# UNITED STATES PATENT AND TRADEMARK OFFICE

| APPLICATION NO.   | FILING DATE | FIRST NAMED INVENTOR | ATTORNEY DOCKET NO.       | CONFIRMATION NO.       |
|---|-------------|----------------------|---------------------------|------------------------|
| 10/578,983  | 08/08/2006  | Helge-Ruben Halse    | 007831.00004              | 8549                   |

## Office Action Summary

### **DETAILED ACTION**

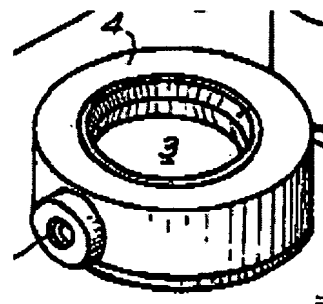
2. The disclosure is objected to because of the following informalities: In paragraph 39 (page 7, line 21 as indicated), the reference to back-up tong should be amended, i.e., "figures 1 and 2" should be changed to, --figure 5--.

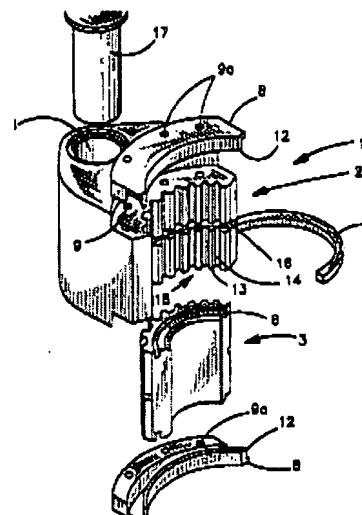
Montgomery et al. meets all of the limitations of claim 1, e.g., in Figs. 1-4, except for disclosing the clamping device communicating with the fluid supply via a swivel ring that encircles the drive ring, and that the plurality of the clamping devices (15) gathered in a group are removable from the drive ring. AAPA, e.g., page 1, lines 5-9, discloses that tongs having a swivel coupling surrounding the tong for transferring pressurized fluid from an external source to the tong is old and known in the art. It is further noted that it has been held that constructing a formerly integral structure in various elements involves only routine skill in the art. *Nerwin v. Erlichman*, 168 USPQ 177, 179. It would have been obvious to one having ordinary skill in the art at the time the invention was made to modify the invention of Montgomery et al with swivel coupling and to make the jaws separable for easing of maintenance or replacements, as these are old and well known in the art and would only require routine experimentations with predictable results.

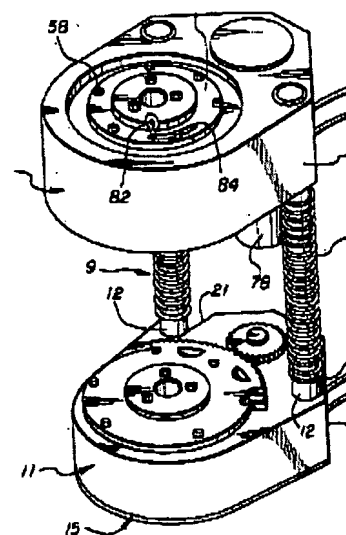
Prior art as applied to claim 1, meets all of the limitations of the above claims, except for disclosing a back up tong displaceable relative to the tong along two guide columns. Providing back up tong for break up and tightening of pipes and adjusting a relative distance between the tong and the back up tong along guide columns are known as evident by Keast et al. It would have been obvious to one of ordinary skill in the art, at the time the invention was made, to further modify the modified invention of prior art with guide columns as taught by Keast et al. to enhance the operation.

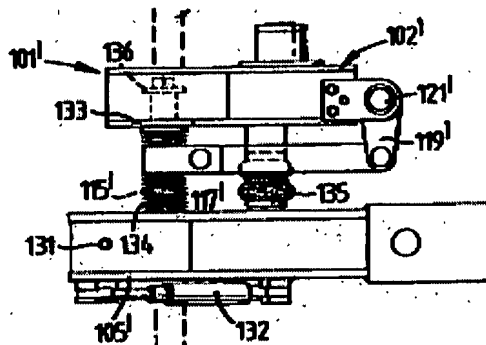
Prior art as applied to claim 1, meets all of the limitations of the above claims, except for disclosing a bellows between a back up tong and the tong. Providing back up tong for break up and tightening of pipes and providing a collecting bellows between the tongs is known as evident by Schulze-Beckinghausen. It would have been obvious to one of ordinary skill in the art, at the time the invention was made, to further modify the modified invention of prior art with a collecting bellows as taught by Schulze-Beckinghausen to enhance the operation.
